- 1. Release Date: 03/27/2019
- 2. Service Letter No.: SL45 65-17800
- **3. Reason for Change:** Optional installation of protective panel for docking and mooring operations.
- 4. Part/Assembly No.: 65-17800, 65-17801
- 5. Float Model Affected: 6650 or 6750
- 6. Disposition of Product in Field: NA
- 7. Compliance: Mandatory

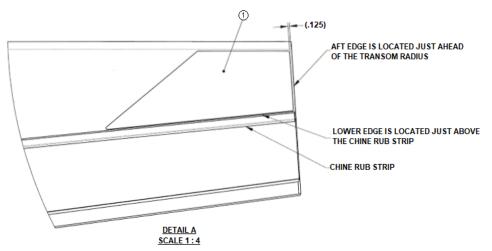
Recommended 
  Optional
- 8. Approval: All information provided is in accordance with approved data.
- 9. Corrective Action: NA
- 10. Time Required: 1 hour (does not include prime and paint options)
- 11. Payments to customer: None. Call (208) 448-0400 for Parts Department
- 1. 65-17800 scuff panel installation, similar for all locations. Left hand, outboard side is shown. All other locations are similar. (See below—6650 shown)

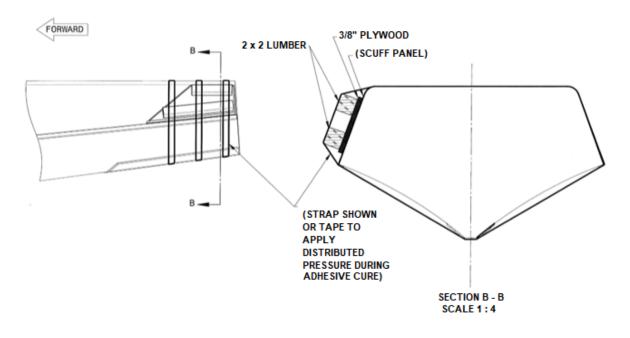
2. 65-17801 (Scuff Panel) is used for both LHS and RHS floats.

- 3. Installation is generally only applied to the outboard sides, such as LHS installation applied to the outboard side of the left float hull. This does not prohibit installation to inboard sides if needed.
- 4. Locate the panel as shown near the transom of the hull and above (not touching) the chine rub strip. Use a marking device to trace the outline for preparation.
